April 23, 2014

**OUR REF:** TO3157TOA00

## **RE: 67/71 Marquette Avenue Redevelopment Transportation Overview**

**Attachment 1**  
Proposed Site Plan

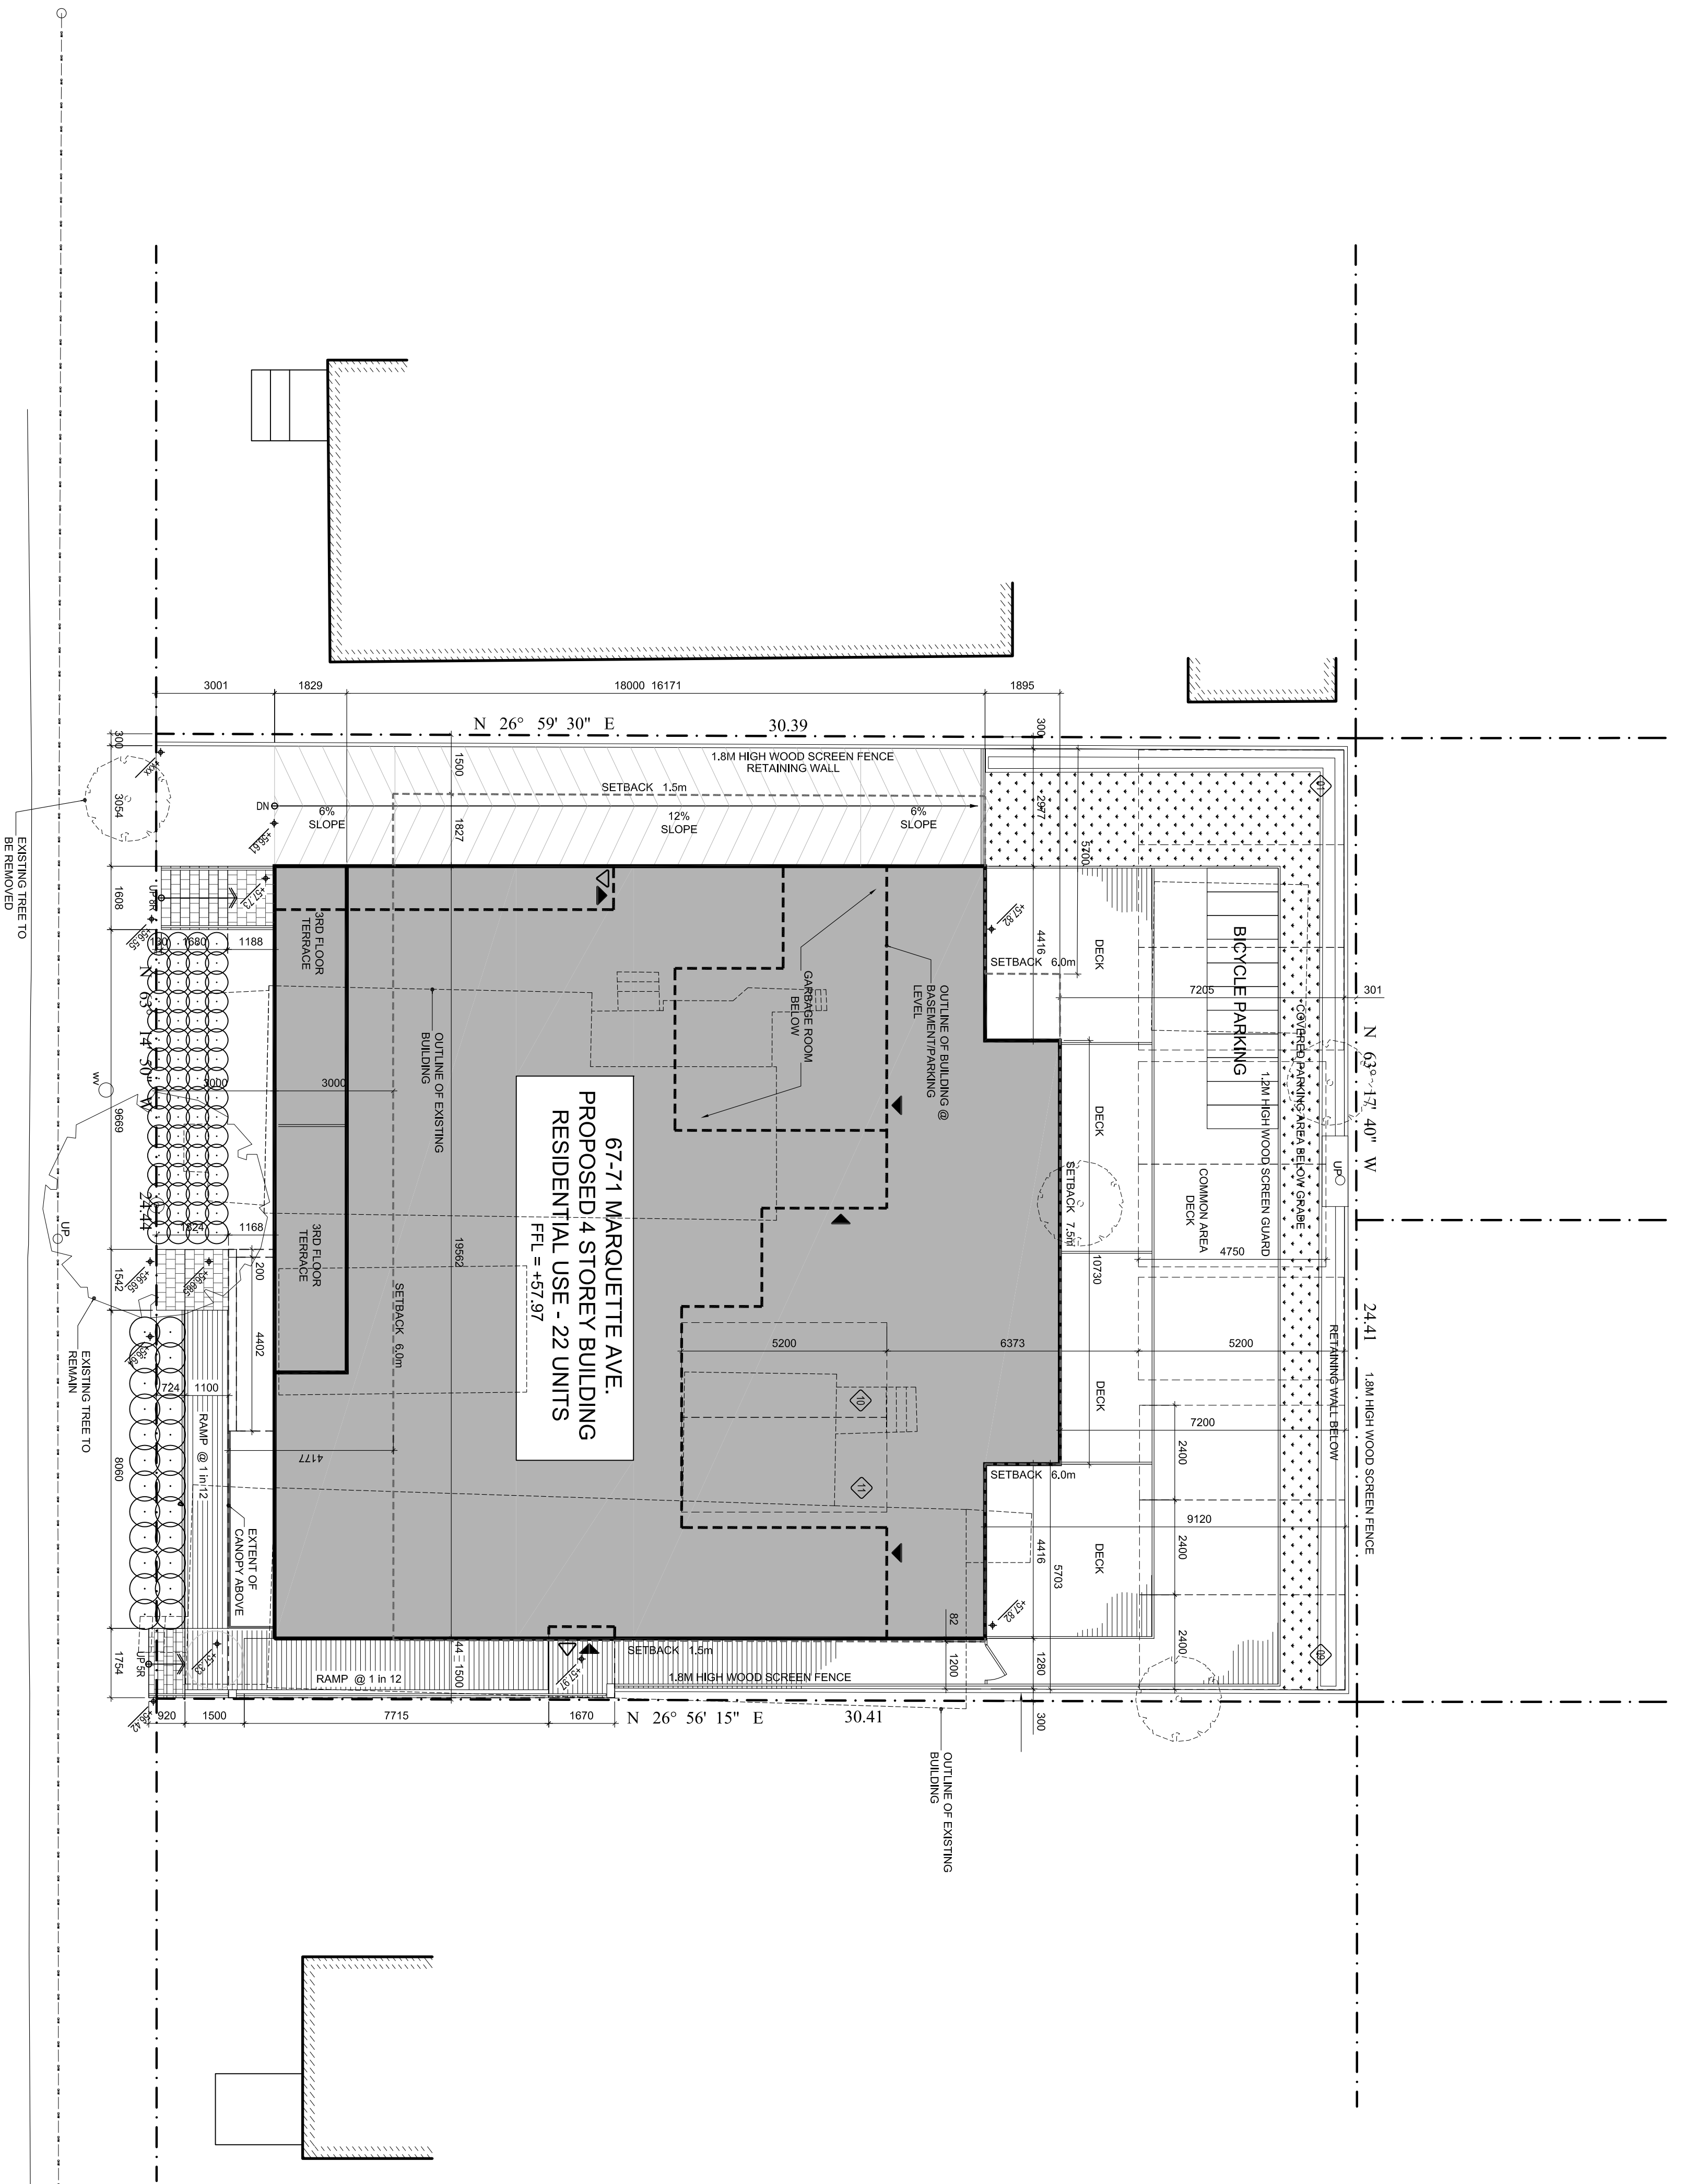
The proposed Site Plan (attachment 1) indicates a single driveway connection to Marquette Avenue will be provided, roughly in the same location as the existing driveway serving No. 67 Marquette Avenue. This single driveway will replace the two existing driveways connecting to Marquette Avenue. The location of the proposed driveway does not meet the 3.0 m minimum setback required in the City's Private Approach By-Law, however a reduced setback (0.3 m as proposed) can be approved through Site Plan Control if there are no safety or traffic operations concerns. As there is no adjacent driveway and as sight lines are good, the 0.3 m setback is considered acceptable from a traffic operations perspective.

The proposed driveway is 3.0 m wide and leads to a single level of below-grade parking located at the rear of the property. The ramp width is sufficient for one-way travel only. While not ideal, given the low number of parking spaces served by the driveway and the fact that they are all designated resident parking spaces, users will familiarize themselves with the need to exercise caution and be prepared for oncoming vehicles. Installation of a convex mirror at the base of the ramp would be beneficial to permit drivers to see if another vehicle is about to access the ramp. The ramp grade (12% with 6% transitions at the top and bottom) is acceptable but will require installation and maintenance of a subsurface melting device by the developer/property owner. The setback from the top of the ramp to the property line along Marquette Avenue does not meet the requirements of the City's Private Approach By-law but is considered acceptable given the small number of parking spaces served, and existing traffic volumes, speeds and sight lines along Marquette Avenue.

Eleven (11) vehicle parking spaces are proposed, which according to the applicant meets the Zoning By-Law requirement. Two (2) required visitor parking spaces are not provided and will require a variance to be obtained. There appears to be an adequate supply of on-street parking available along Marquette Avenue, particularly with the recent addition of 10-15 new on-street parking spaces adjacent to the public park located on the next block to the northwest along Marquette Avenue. The elimination of an existing site driveway will result in the creation of additional on-street parking (1 additional space) directly in front of the proposed development. By-Law requirements are parking spaces at 2.6 m wide x 5.2 m long and circulation aisles at 6.7 m wide. A marginally narrower width is acceptable given the small number of parking spaces but consideration should be given to revising the Site Plan to accommodate the minimum By-Law dimensions.

Eleven (11) bicycle parking spaces are proposed, which meets Zoning By-Law requirements. These spaces are located on the ground level at the rear of the property and accessed via a pedestrian connection which runs along the east side of the building. The Site Plan does not indicate if the proposed bicycle parking is covered, which would increase its utility and attractiveness to residents. The addition of a small "post and ring" bicycle parking facility at the front of the building should also be considered to provide a convenient parking location for visitors.

- The proposed driveway width is sufficient to permit one-way vehicle travel only, but is considered acceptable given the small number of parking spaces provided on-site and the fact that they are all designated for residents. Safety measures such as a convex mirror at the base of the ramp to improve visibility and provide an indication of oncoming traffic should be installed to improve operations;

- The proposed driveway does not meet Private Approach By-Law requirements in terms of the setback from the adjacent property or the setback from the top of the ramp from Marquette Avenue. Given the low number of trips the proposed development will likely generate, combined with the low volume of traffic and good sightlines available along Marquette Avenue, the proposed location of the site driveway is considered both safe and acceptable;

- The proposed parking spaces and drive aisle width are slightly below the minimum dimensions required in the City's Zoning By-Law but are also considered acceptable

given the small number of parking spaces. Consideration should be given to revising the Site Plan to accommodate required dimensions;

- The proposed number of vehicle parking spaces meets By-Law requirements for resident parking, however the 2 required visitor parking spaces are not provided. Sufficient on-street parking along Marquette Avenue appears to be available, and the consolidation of the two existing driveways on the site will provide for an additional on-street parking space; and
- The proposed number bicycle parking spaces meets By-Law requirements. Consideration should be given to provide an enclosed bicycle parking facility for residents, and some additional bicycle parking at the front of the building for visitors.
